ADDENDUM NO. 3

- A. Date: 22 March 2013
- B. From: Bahr Vermeer and Haecker Architects, Ltd.
- C. To: Prospective Bidders.
- D. Project: Lexington Public Schools Lexington Middle School and Community Recreation Facility Addition 100% Contract Documents
- E. This addendum is issued by the Architect to all bidders of record prior to receipt of proposals. Bidders shall acknowledge receipt of this addendum by so indicating on the Bid Form. Failure to do so may subject Bidder to disqualification.
- F. All information and instructions given herein shall become a part of the Contract Documents.

A15 ENLARGED PLAN - CRF ADMIN DESK
1/2" = 1'-0"

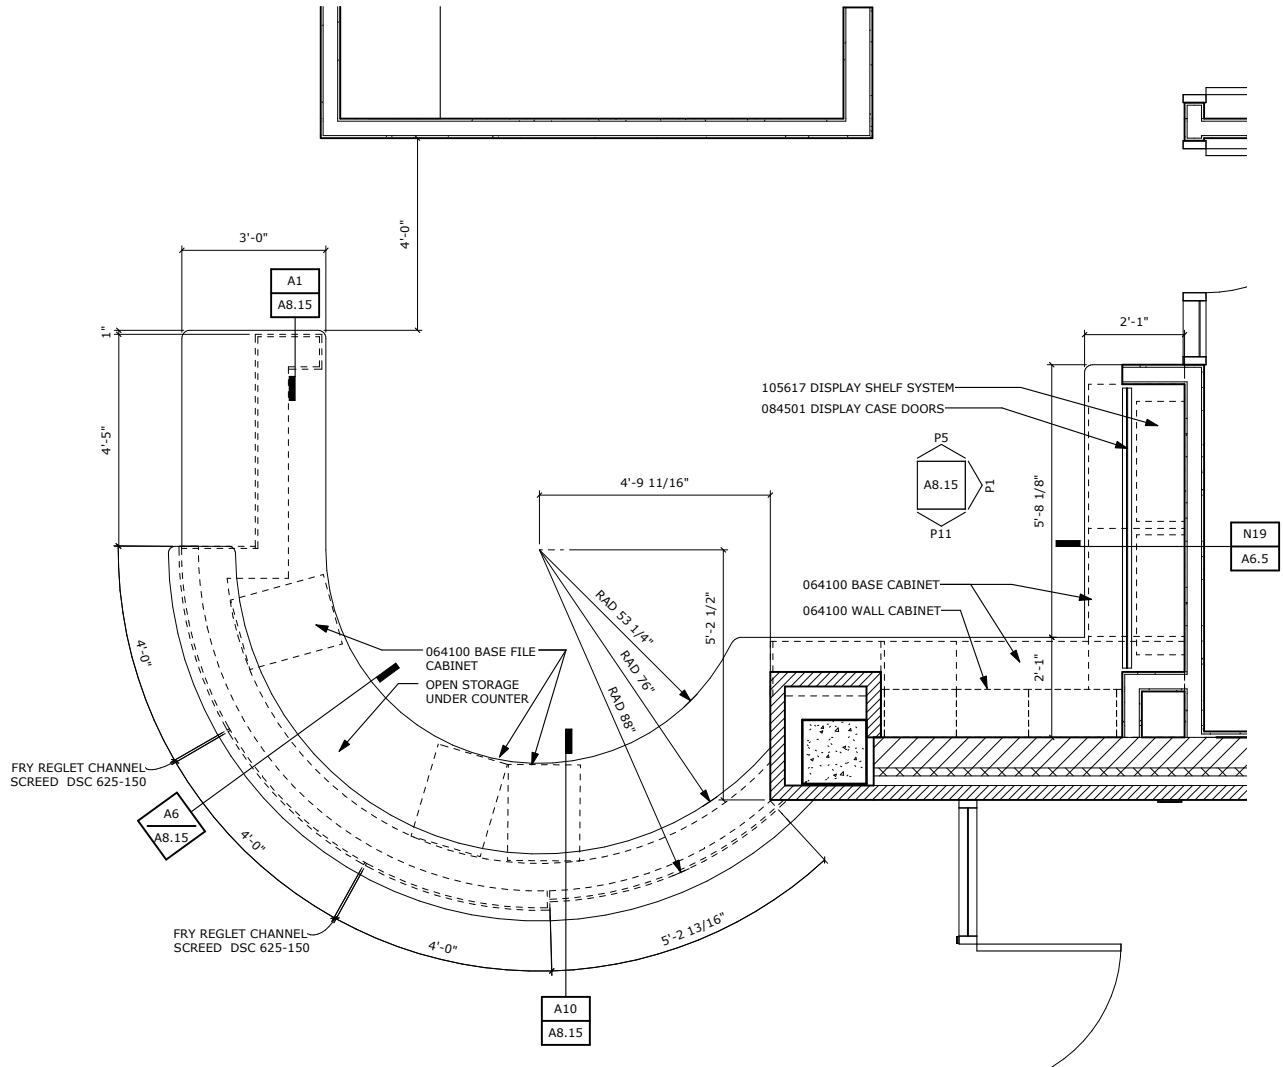
2. Delete the top horizontal 7" intermediate frame from Frame Type A38 (located on sheet grid P-23).
- C. Sheet A8.15 Interior Elevations:
1. CRF Admin Desk Plan is attached. The original drawing did not print.
- D. Sheet A9.1 Room Finish and Materials List:
1. Revise Materials List 096500 Resilient Base RB-1 and RB-2 Style, Size, and Accessories to: See Specifications.
- E. Sheet S2.0 General Notes:
1. Add Note to 3.1 Steel:
- J. Open-web steel joists shall be designed such that the space between diagonal web members remain clear of vertical members where mech ducts pass through the joist.

M3.2B

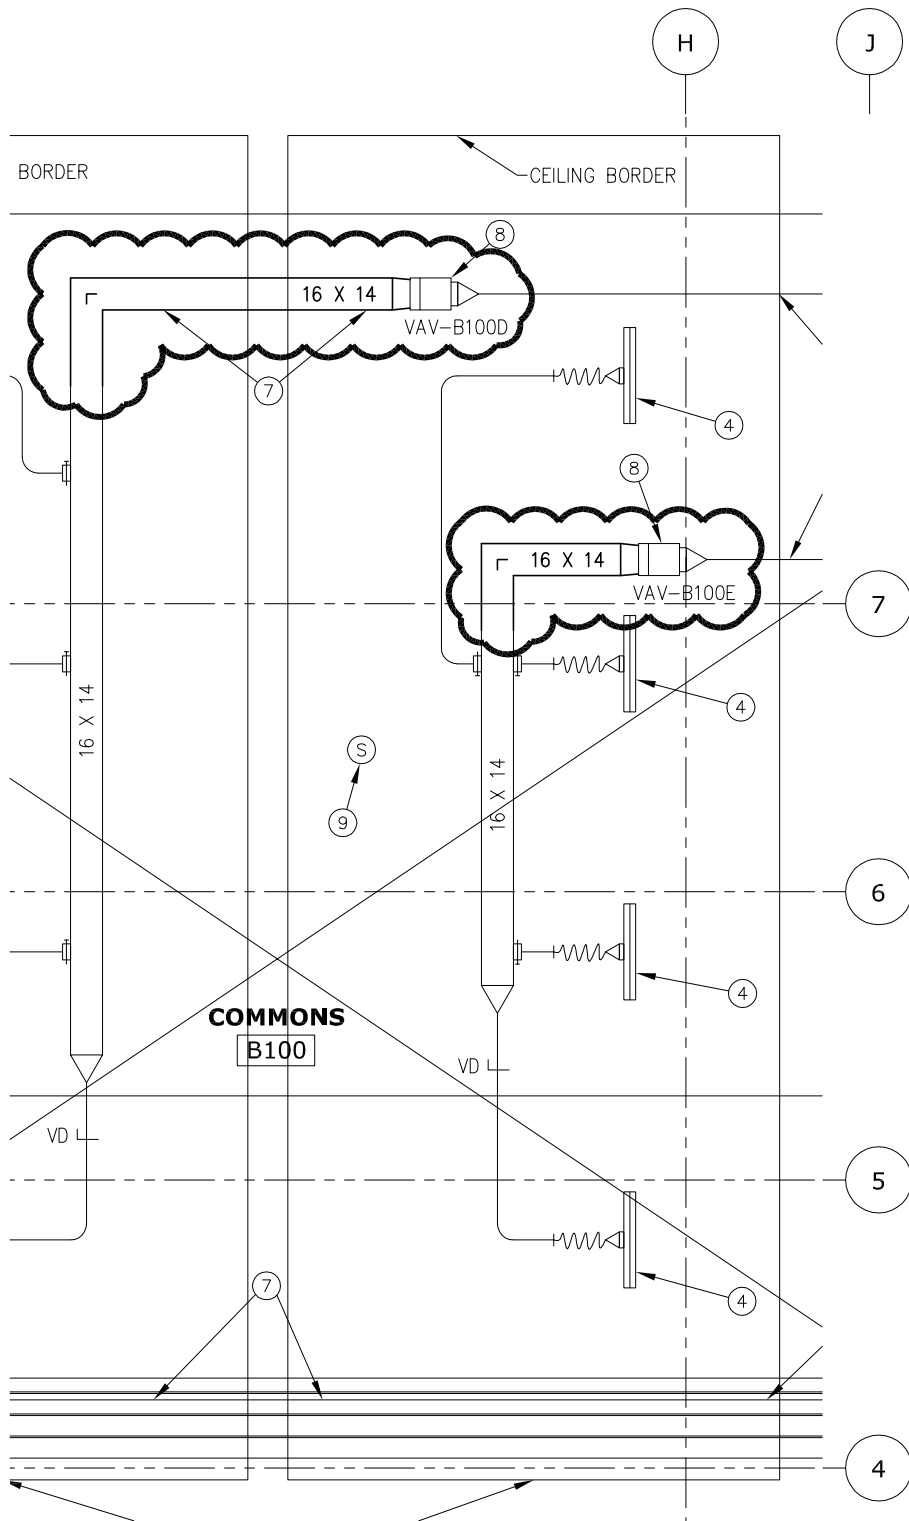
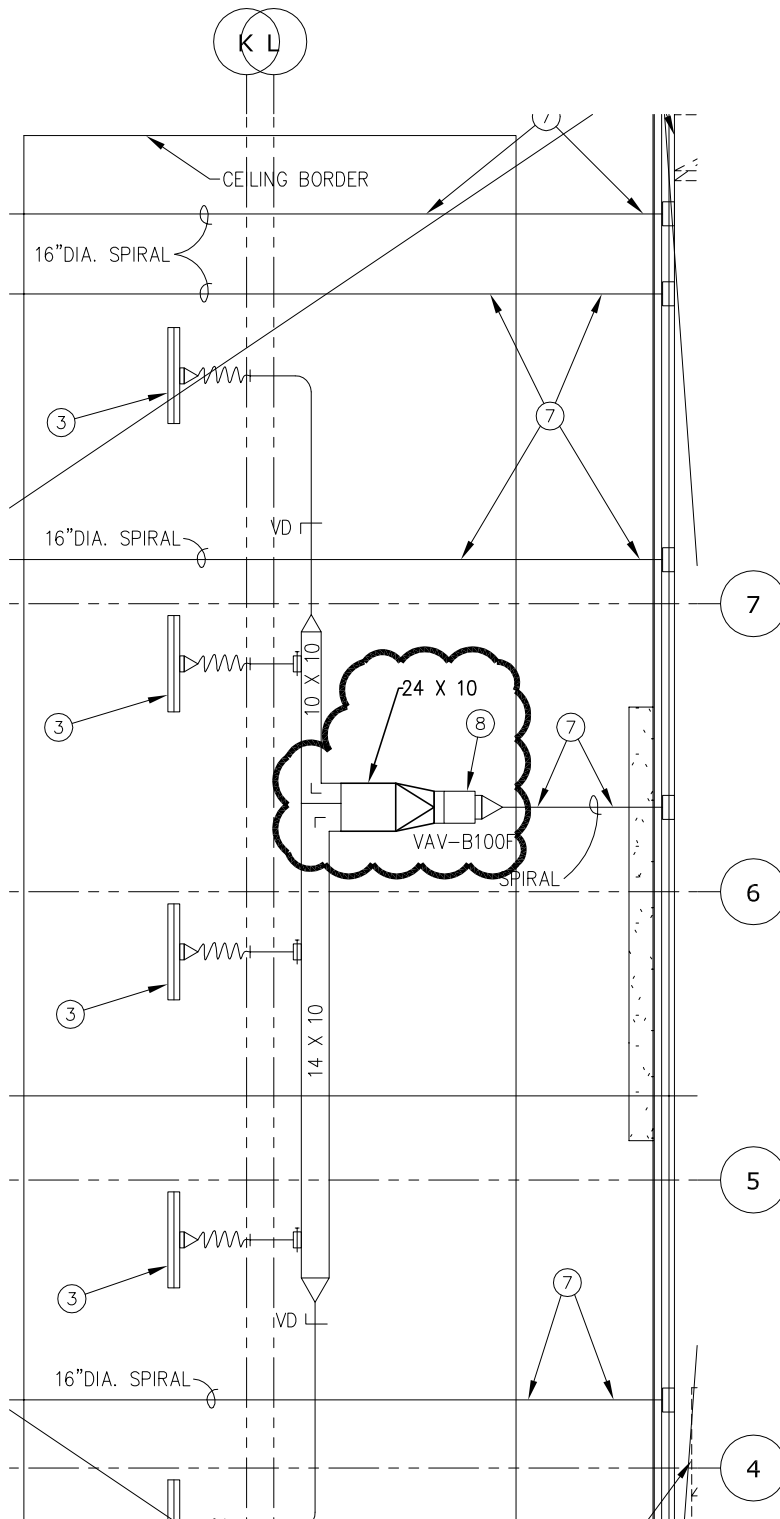
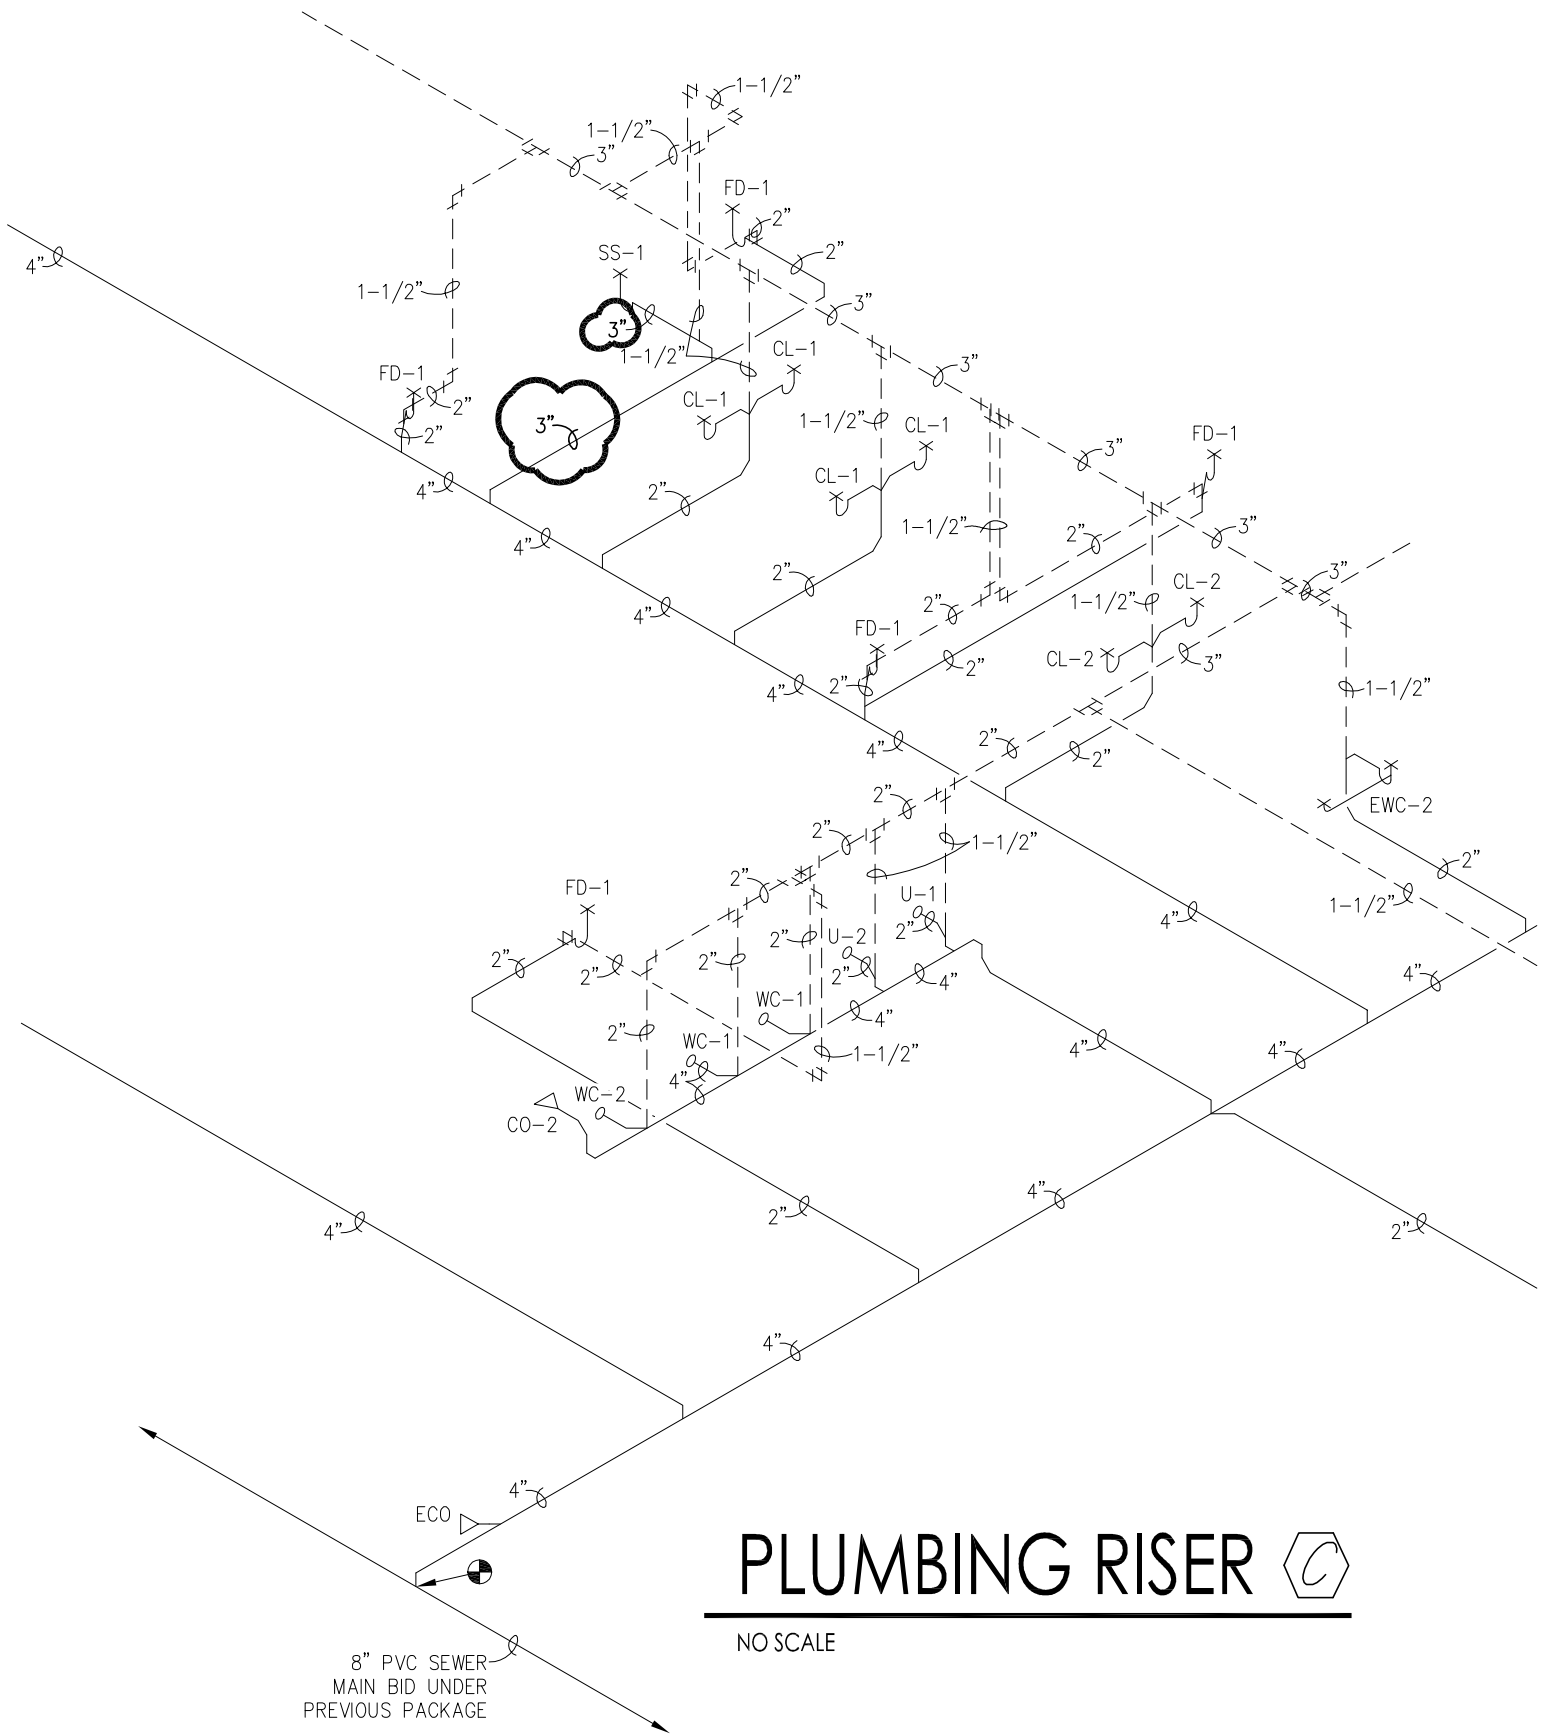
- 1. Sheet M1.1D First Floor Plan – Area D - Plumbing
A. Increase Service Sink (SS-1) drain in Custodial 121 from 2” to 3” to handle elevator sump pump discharge.
B. Remove sheet note #13 in its entirety referring to extending the elevator sump pump remote alarm indicator into custodial D106 and mount on wall.
2. Sheet M3.2B Second Floor Plan – Area B - HVAC
A. See sheet M3.2B-1 for changes to the HVAC plan.
B. See sheet M3.2B-2 for changes to the HVAC plan.
C. See sheet M3.2B-3 for changes to the HVAC plan.
3. Sheet M5.2 Mechanical Details
A. Elevator Sump Pump Detail: change sump pit basin size from 16” diameter to 24” diameter. Change sump pit basin size from 24” depth to 36” depth.
